Trumbo Village

SHERIFF'S EMPLOYEE HOUSING
MAJOR DEVELOPMENT PLAN
255 TRUMBO ROAD

Amendment to Conditions of Approval

Proposed Site Plan

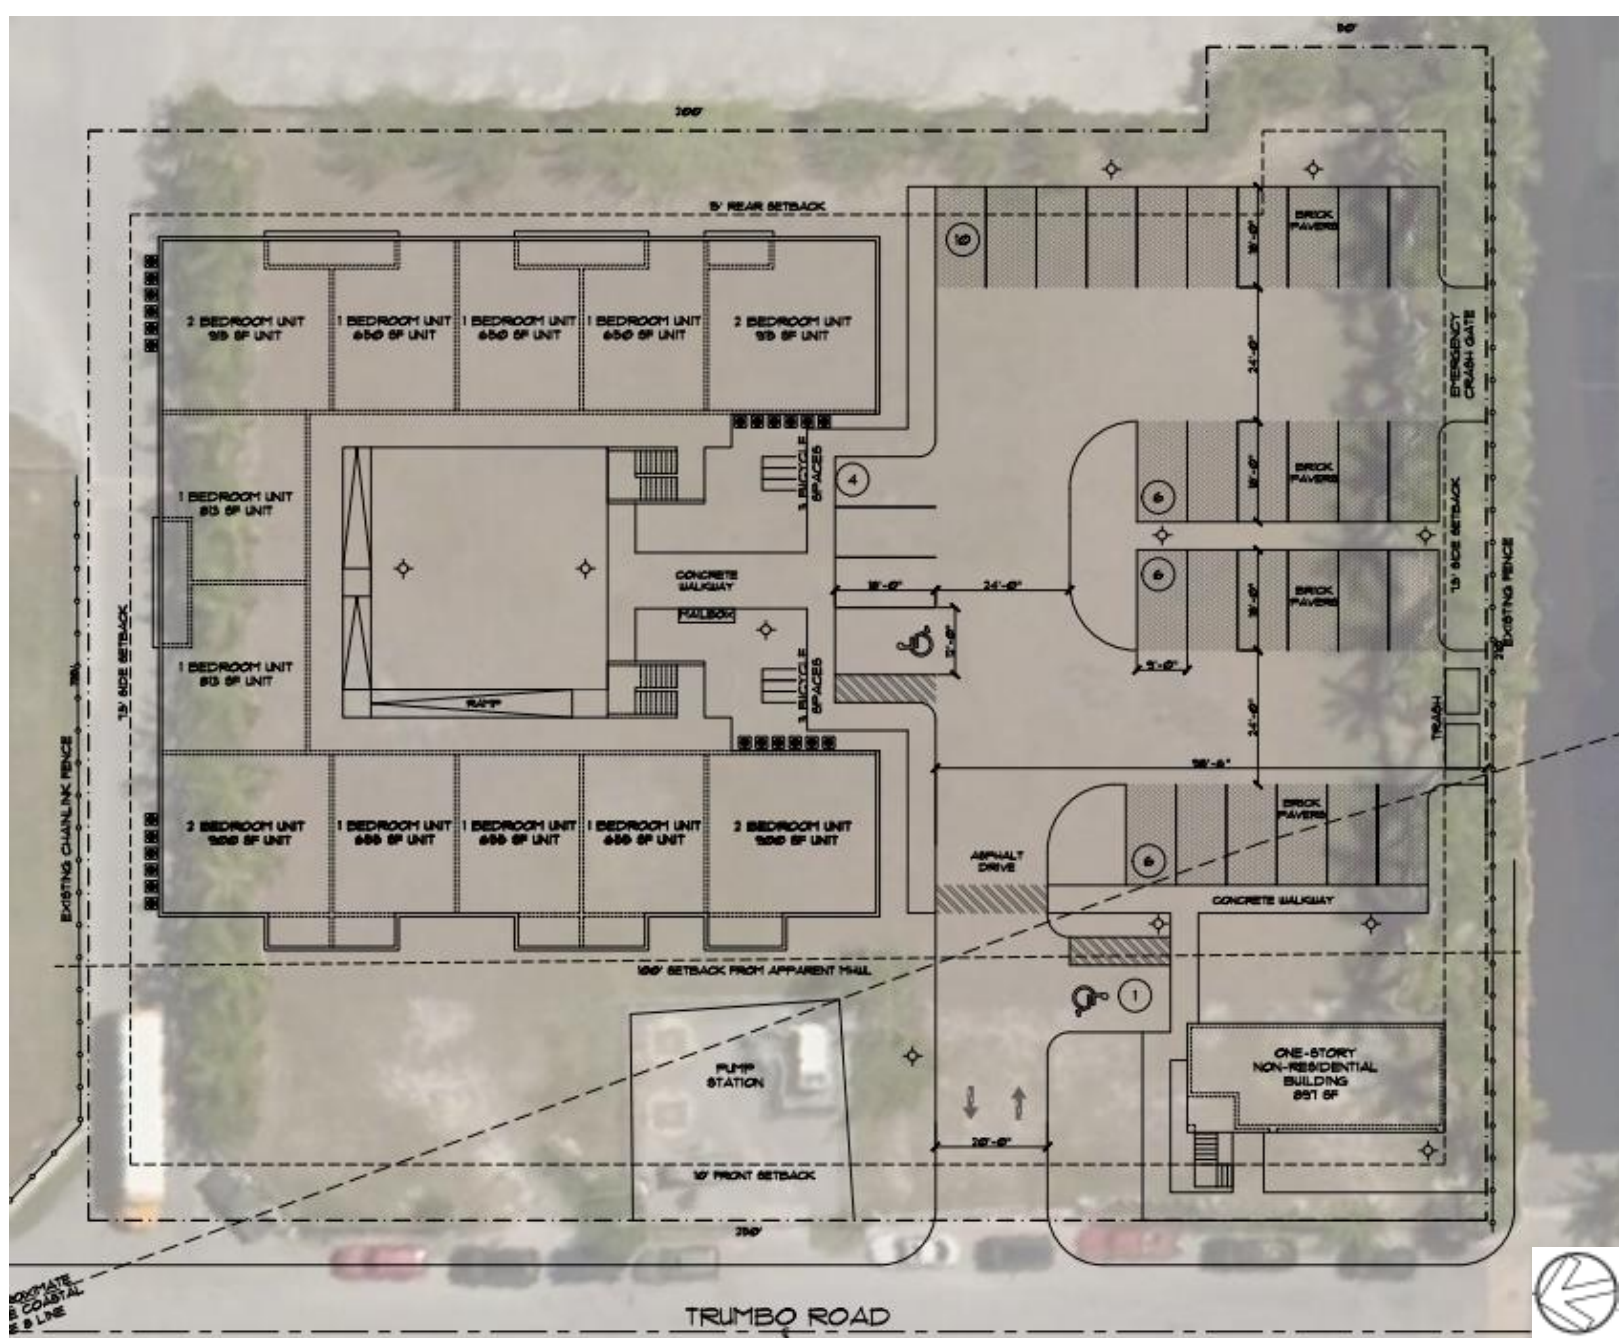
~~3. An ADA compliant five foot sidewalk is required adjacent to the Trumbo Road right of way and must tie into the existing grid with ADA connections across any driveway.~~

Rationale for Deletion: It is important to keep in mind this is an affordable housing project, there is no budget available for wishful development proffers. Sec. 107-28 requires: sidewalk connection between parking, principal structures and adjacent activity areas. The proposed plans comply with this requirement. Installation of public sidewalks along Trumbo Road is not a requirement of code.
